ST. LOUIS STREET-DEARBORN SUBDIVISION

Engineering Comments: FINAL PLAT COMMENTS (should be addressed prior to submitting the FINAL PLAT for review and/or signature by the City Engineer):

The plat illustrates the proposed 1-lot, 0.4± acre subdivision which is located on the Northwest corner of St. Louis Street and North Dearborn Street, within Council District 2. The applicant states that the subdivision is served by city water and sanitary sewer systems. The purpose of this application is to create one (1) legal lot of record from two (2) metes-and-bounds parcels.

DETAIL SITE PLAN

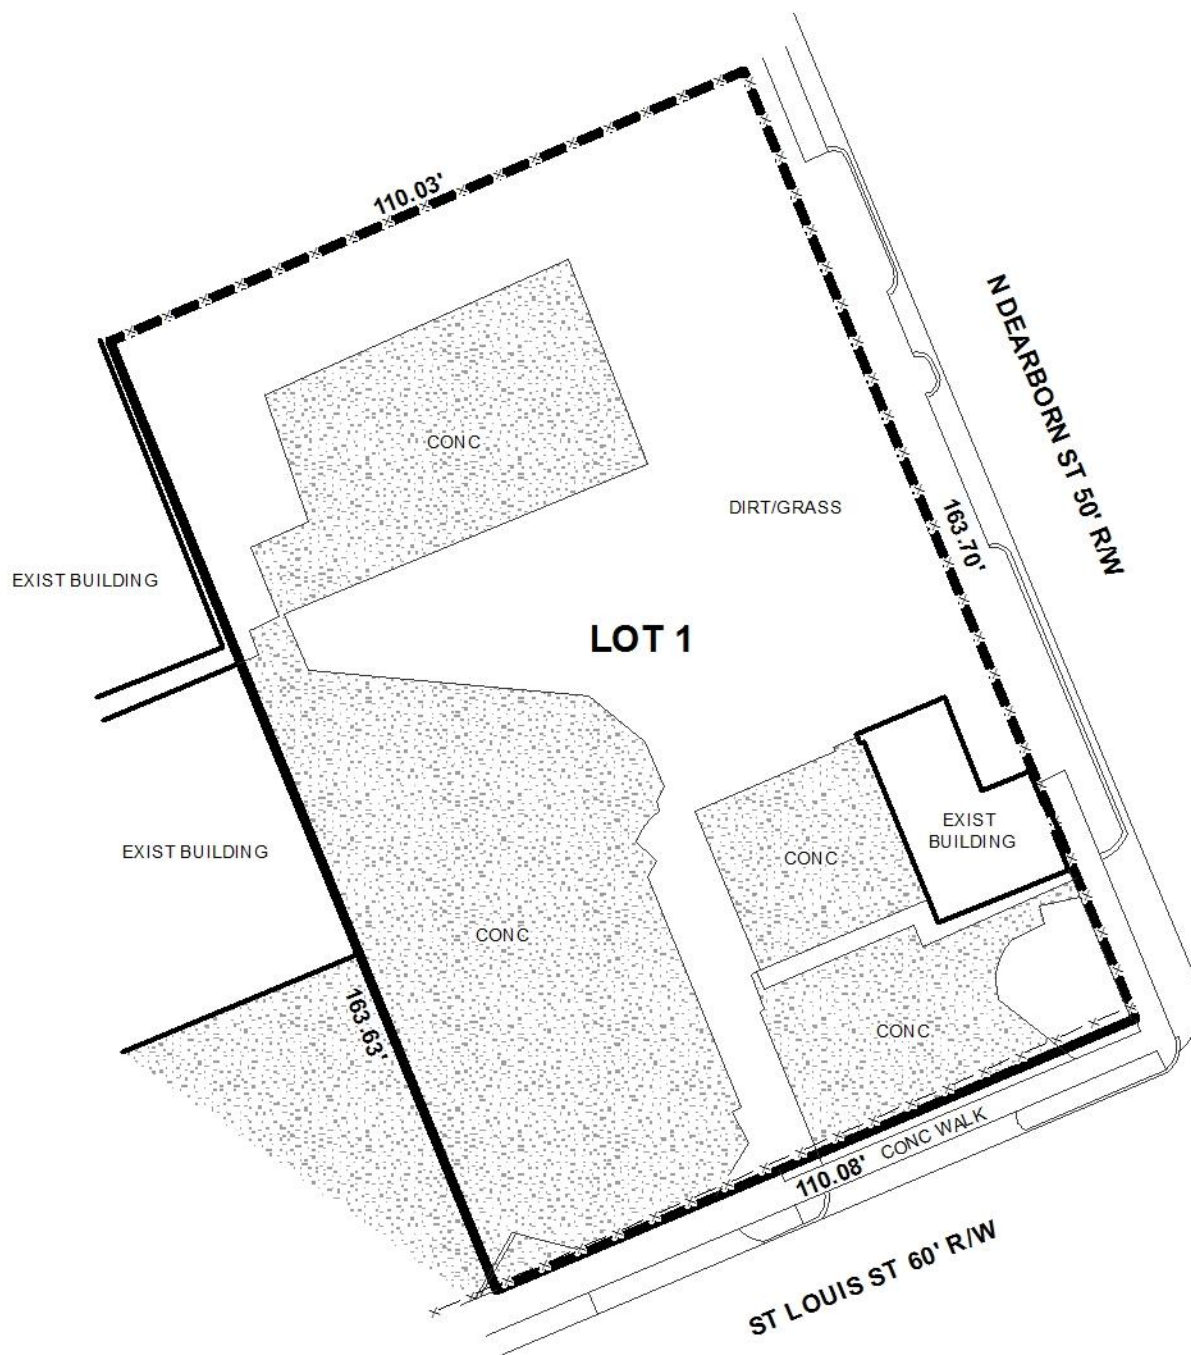
- B. Dedicate the corner radius (25' minimum or as approved by the City Engineer and Traffic Engineer) at the southeast corner of LOT 1 to the City of Mobile, and list the amount of dedicated acreage.

- C. Show and label all flood zones.
- D. Show and label the MFFE (Minimum Finished Floor Elevation) on each lot that contains an AE, V, or X (shaded) flood zone designation.

There are no building setback lines illustrated on the preliminary plat. The DDD, per Section 64-3.I.8.(d), allows from 0’ minimum to 10’ maximum setback along the primary street frontage, and a 0-foot setback along the secondary frontage and all other property lines (subject to fire rating requirements) in SD-WH districts. If approved, the Final Plat should be revised to illustrate a 10’ maximum building setback line along the primary street frontage, with a note stating a 0’ minimum is allowed.

Section 64-3.I.11.(c)5. of the DDD regulations limits lots to one curb-cut per property frontage, with access to parking to be from a secondary frontage (a “B” street) where possible. It appears that the site has more than one existing curb-cut per frontage, thus any extra curb-cuts should be removed at the time of any site construction or redevelopment. As a means of access management, the Traffic Engineering comments should be placed on the Final Plat, if approved.

- 2) Illustration of a 10' maximum building setback line along the St. Louis Street frontage, with a note stating that 0' minimum building setback is allowed along all frontages and property lines;

- 3) Retention of lot size information in both square feet and acres;
- 4) Placement of a note on the Final Plat stating that each lot is limited to one curb cut per street frontage, with any extra curb-cuts to be removed at time of site construction or redevelopment, and with the size, location and design to be approved by Traffic Engineering and conform to AASHTO standards.
